MIL-M-28787/169B
AMENDMENT 2
29 September 1993
SUPERSEDING
AMENDMENT 1
20 September 1983

MODULES, STANDARD ELECTRONIC

MEMORY, READ ONLY, PROGRAMMABLE, DIGITAL, KEY CODE GYF

FIGURE 25. Galloping read access pattern test circuit for table XVIII.

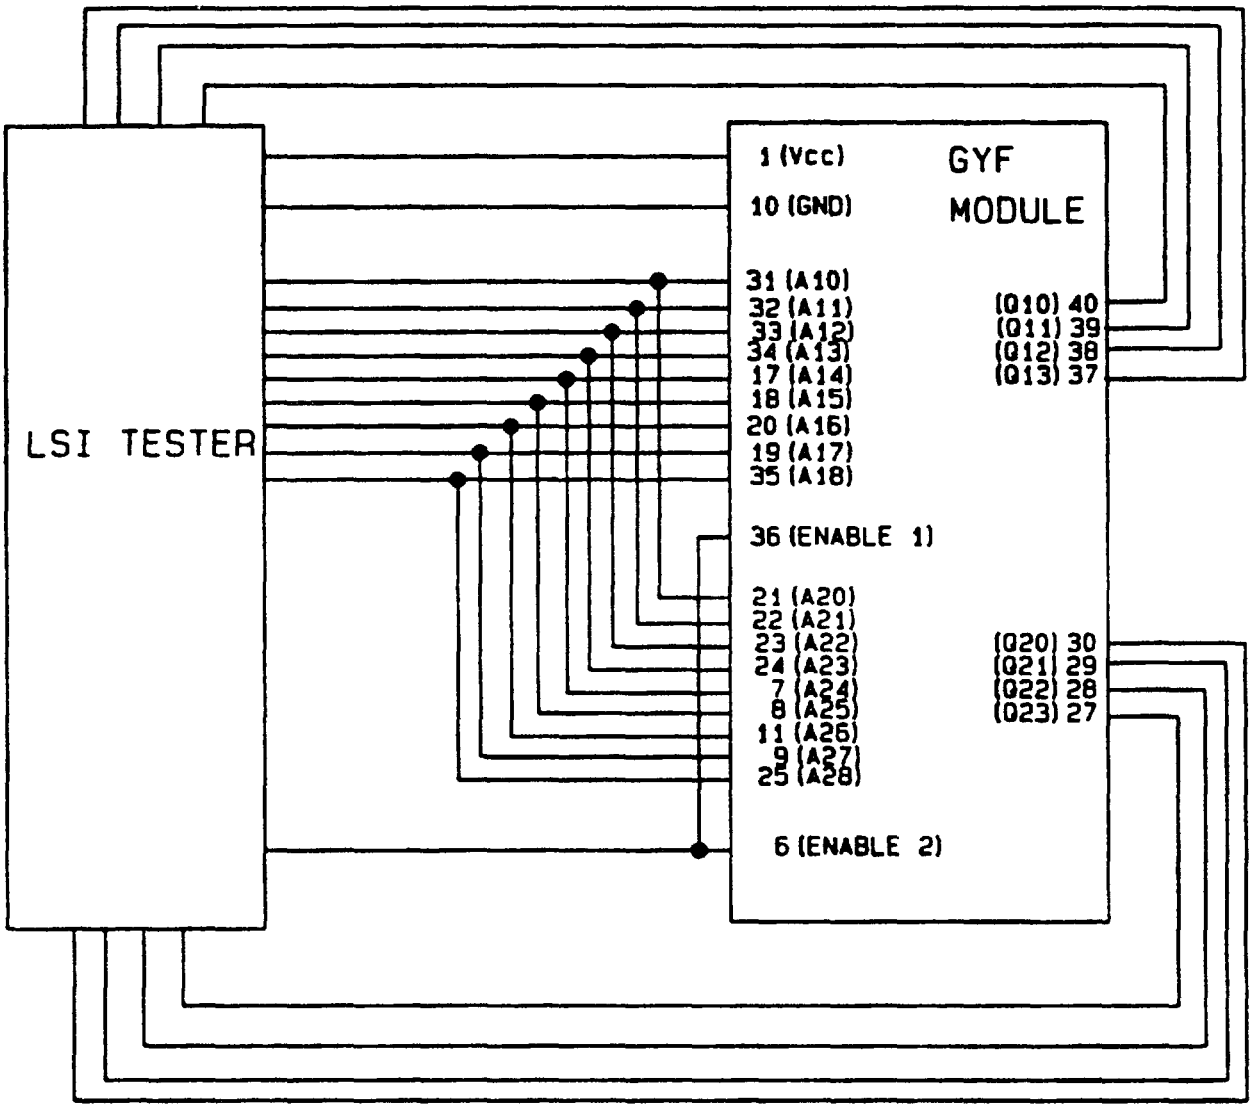
* FIGURE 25: Delete and substitute new figure 25 as printed on page 4 of this amendment.

NOTES:
1. Vcc = 4.5 V ±1% for test conditions V1 and V3.
*2. Vcc = 5.5 V ±1% for test conditions V2 and V4.
3. Load output under test with a load as specified on figure 16.
